**ANGEL PLACE
LEVEL 8, 123 PITT STREET
SYDNEY NSW 2000**

7 June 2022

HERITAGE IMPACT STATEMENT - MODIFICATIONS (MOD 4) TO APPROVED SSD-10371 - TRINITY GRAMMAR SCHOOL – 119 PROSPECT ROAD, SUMMER HILL

Figure 2: Extract from modified SSD Proposed Site Plan B1.

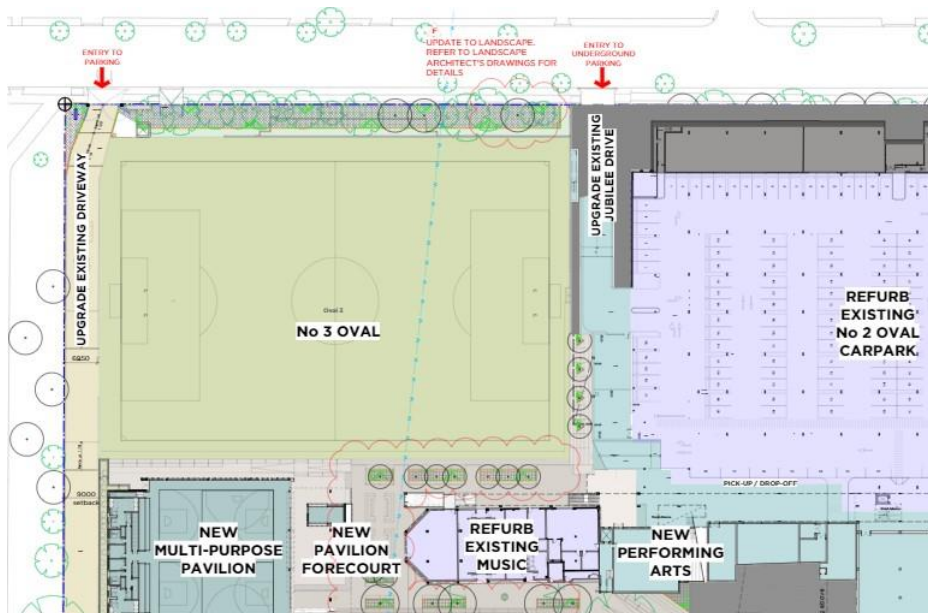
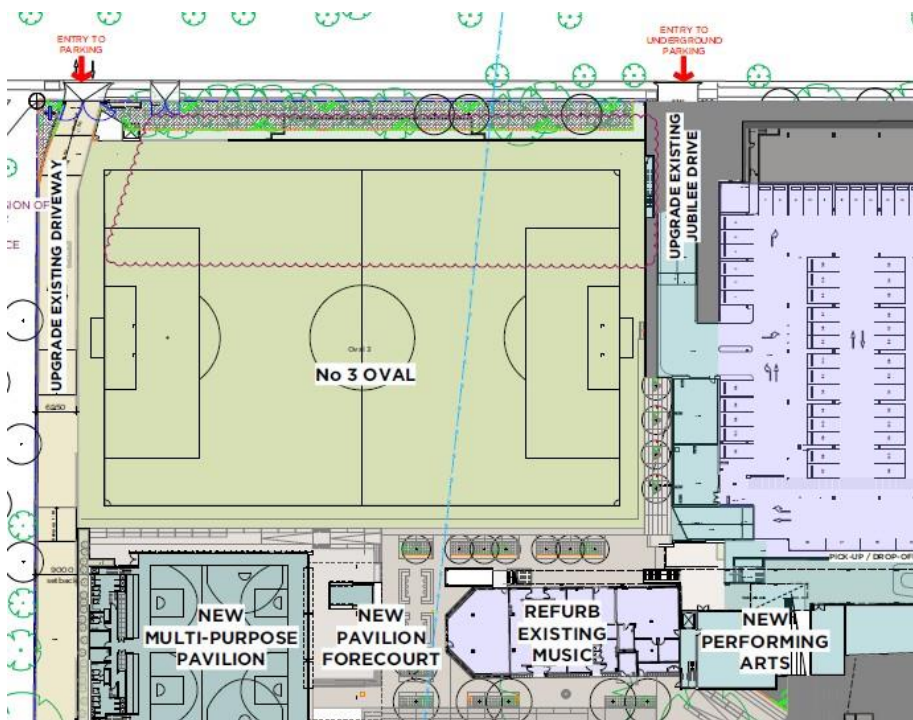
2808 DA111 Proposed Site Plan B1 G

Proposed architectural site plan showing the surface level of Oval 3. The proposed modification is situated under the oval and no changes are envisaged above ground.

Figure 4: Extract from modified SSD Proposed Site Plan B2.

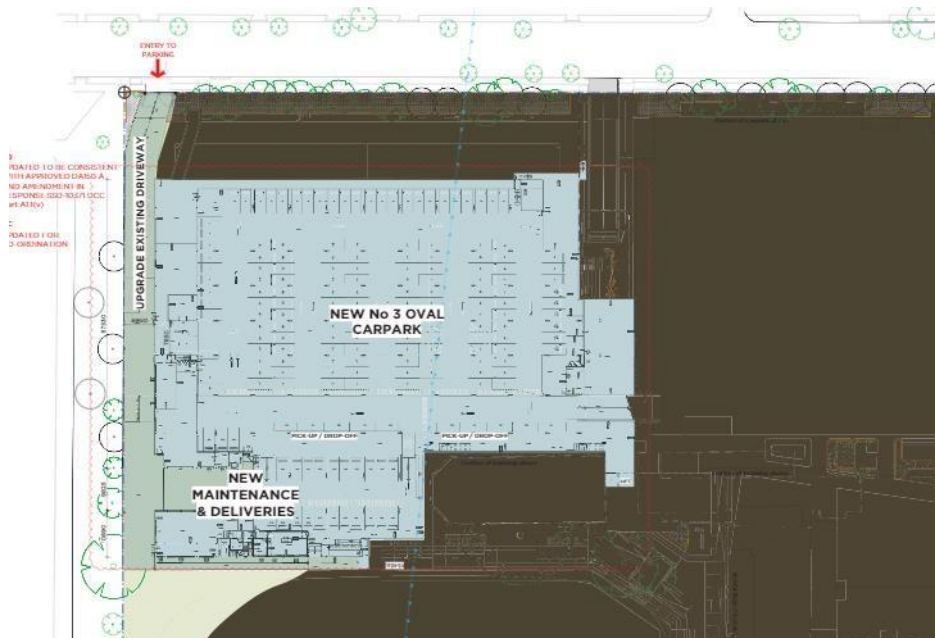
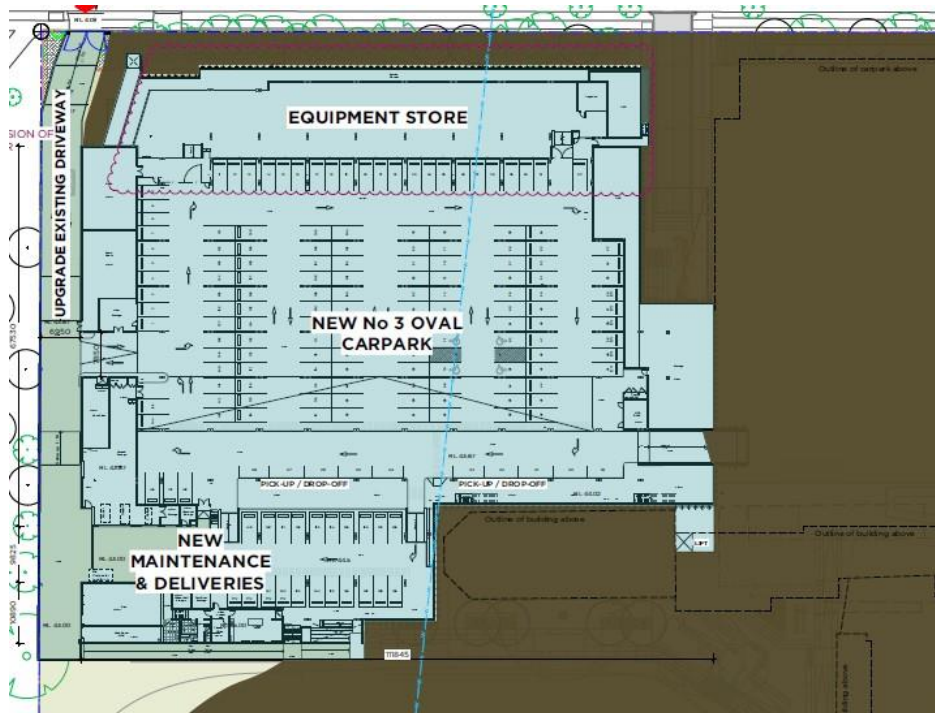
2808 DA110 Proposed Site Plan B2 D

Proposed architectural site plan showing extent of additional basement floor space for equipment store.

Source: PMDL Architecture & Design, Drawing No. DA151, May 2022, Issue F.

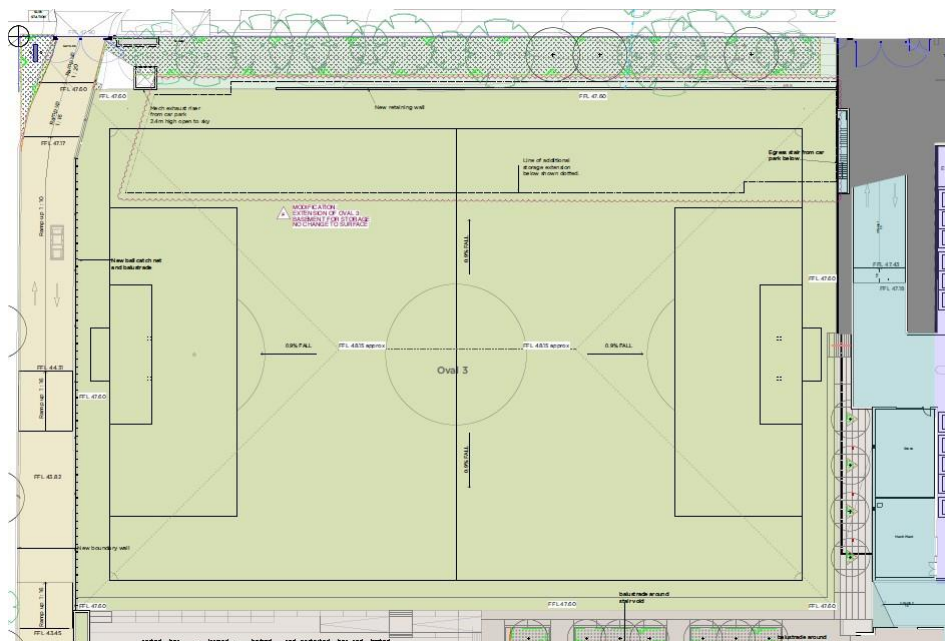
2808 DA151 Proposed Oval 3 Car Park B1 F

Proposed architectural plan showing the surface level of Oval 3. Zone of additional works this modification is seeking approvals for is shown dotted. The oval over the additional works will be re-instated with natural turf, other external elements remain consistent with the approved SSD application, thus visually no changes are proposed for this modification.

Figure 8: Extract from modified Proposed Oval 3 Car Park B2.

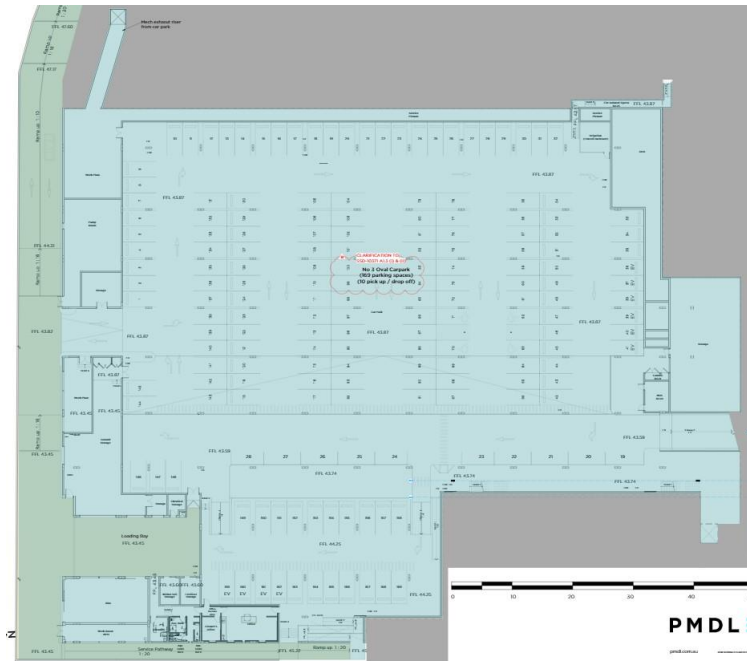
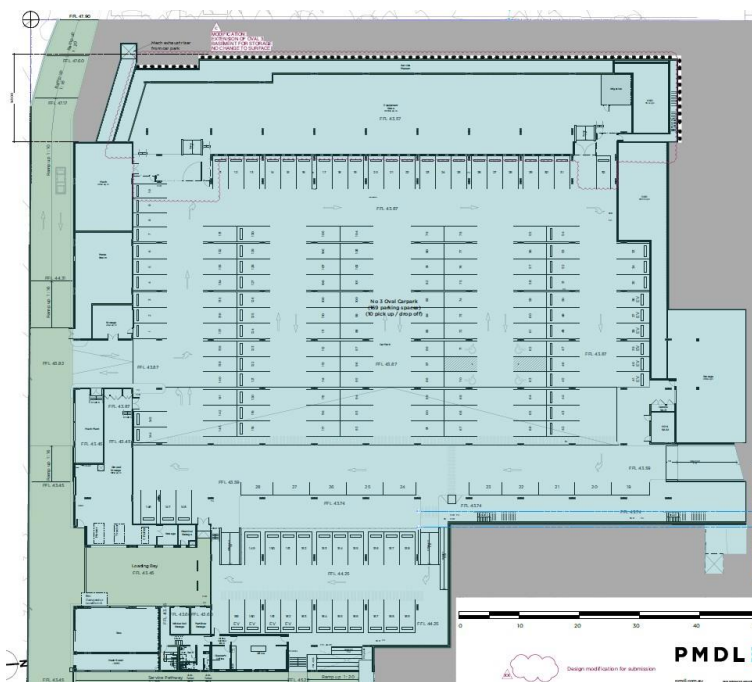
2808 DA150 Proposed Oval 3 Car Park B2 C

Proposed architectural plan showing extent of additional basement floor space for equipment store. A 300mm drop in level in the extension area is required to achieve the School's required height clearance for equipment store. The service plenum is reconfigured and additional OSD introduced to suit new layout. There is no change to the facade, and the Mechanical exhaust plenum and other external fronting elements are not changed thus no impact is envisaged to external facades and frontages. There will be some reconfiguration of car parking spaces along the western row, however total required quantity of car parking as determined in the SSD will be maintained.

Figure 10: Extract from modified SSD Section FF.

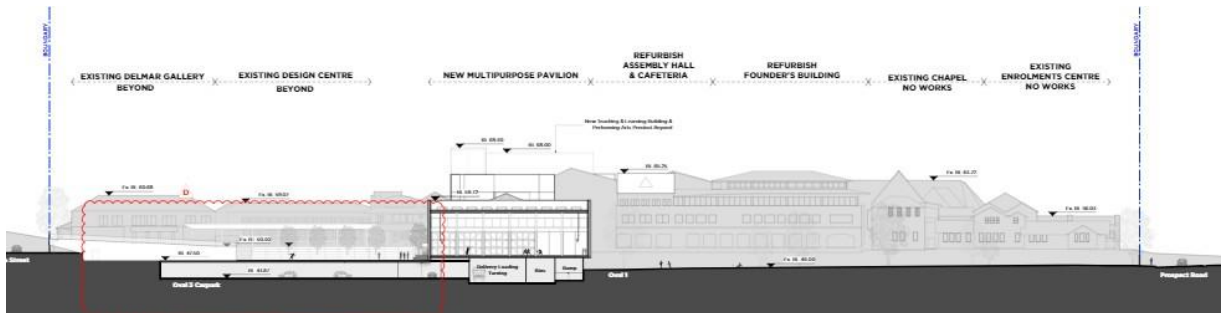
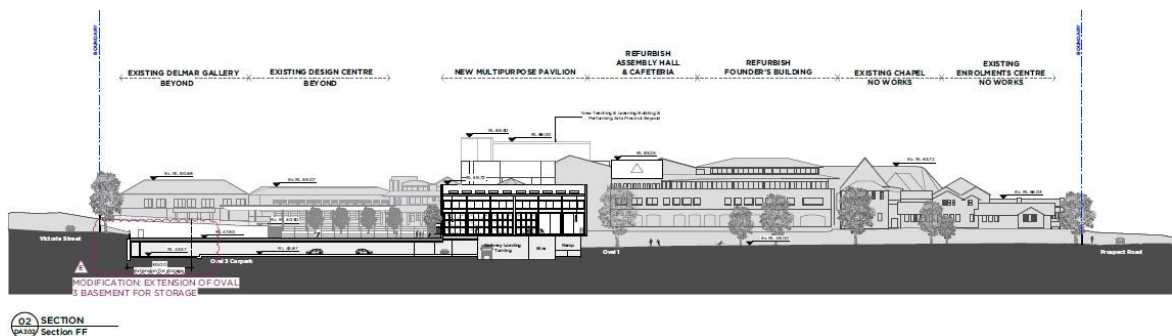
2808 DA302 Site Sections EE_ FF E

Updated section FF shows the additional zone for equipment store proposed for this modification. The oval over the additional works will be re-instated with natural turf, other external elements remain consistent with the approved SSD application, thus visually no changes are proposed for this modification.

Figure 12: Extract from modified SSD Section EE.

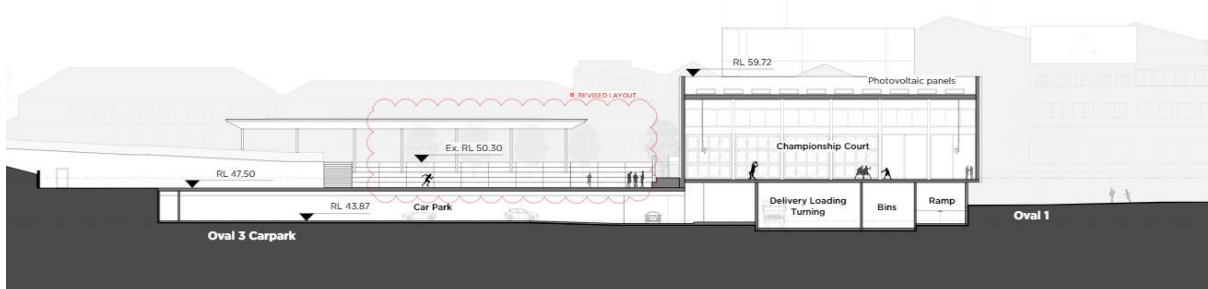
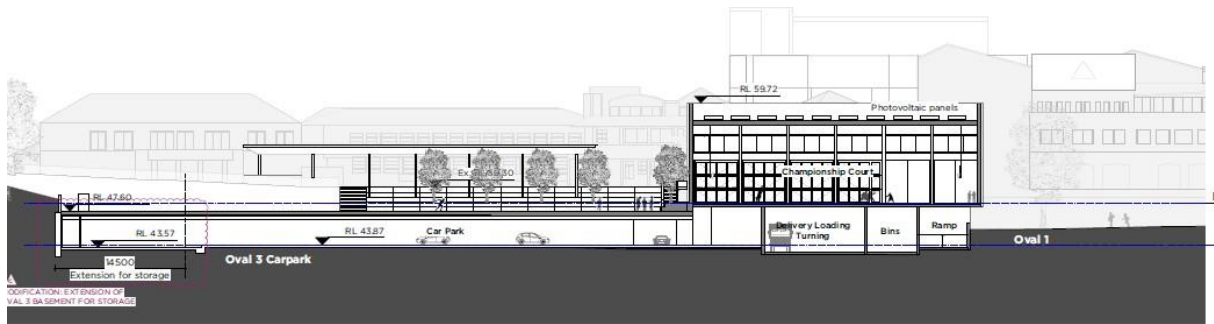
2808 DA334 Site Sections EE C

Updated section FF indicates the additional zone for equipment storage proposed in this modification. The oval over the additional works will be reinstated with natural turf, and other external elements remain consistent with the approved SSD application, thus visually no changes are proposed for this modification.
